Access Compliance Report

Public Rights-of-Way

Intersection ID: 12618	Main Street: E_5TH_ST	Cross Street: N_CALDWELL_ST	Location: S
ADA ID: B0A4D2B5D510	Ramp Type: Perp	Initial Pass/Fail: Fail	Overall Compliance: No
		Severity Score: 12.5

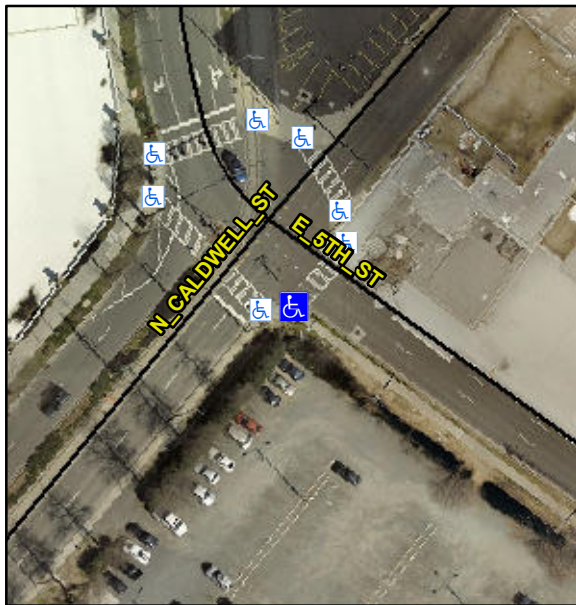
Not Found, R304.2.2

Compliance	Description	Data	Compliance	Description	Data
N/A	Ramp Length (in)	48.0	No	Ramp Slope (%)	8.4
Yes	Ramp Width (in)	49.0	Yes	Ramp XSlope (%)	0.7
N/A	Flare Type LT	N/A	N/A	Flare Type RT	N/A
N/A	Flare Slope LT (%)	N/A	N/A	Flare Slope RT (%)	N/A
N/A	Flare Traversable LT?	N/A	N/A	Flare Traversable RT?	N/A
N/A	Landing Length (in)	N/A	N/A	DWS Provided?	N/A
N/A	Landing Width (in)	N/A	N/A	DWS Contrast?	N/A
N/A	Landing Slope (%)	N/A	N/A	DWS Length (in)	N/A
N/A	Landing X Slope (%)	N/A	N/A	DWS Full Width?	N/A
N/A	Landing Curb? (Y/N)	N/A	N/A	DWS Offset (in)	N/A
N/A	Shared Landing?	N/A			
N/A	Gutter Ponding?	N/A	N/A	Gutter Slope (%)	N/A
N/A	Gutter Lip Ht (in)	N/A	N/A	Gutter X Slope (%)	N/A
N/A	Painted X Walk1?	Yes	N/A	Painted X Walk2?	N/A
	X Walk 1 Direction	To NE		X Walk 2 Direction	N/A
N/A	X Walk 1 Width (in)	110.0	N/A	X Walk 2 Width (in)	N/A
	X Walk 1 Slope (%)	2.6		X Walk 2 Slope (%)	N/A
	X Walk 1 X Slope (%)	3.0		X Walk 2 X Slope (%)	N/A

Remove & Replace Entire Ramp.
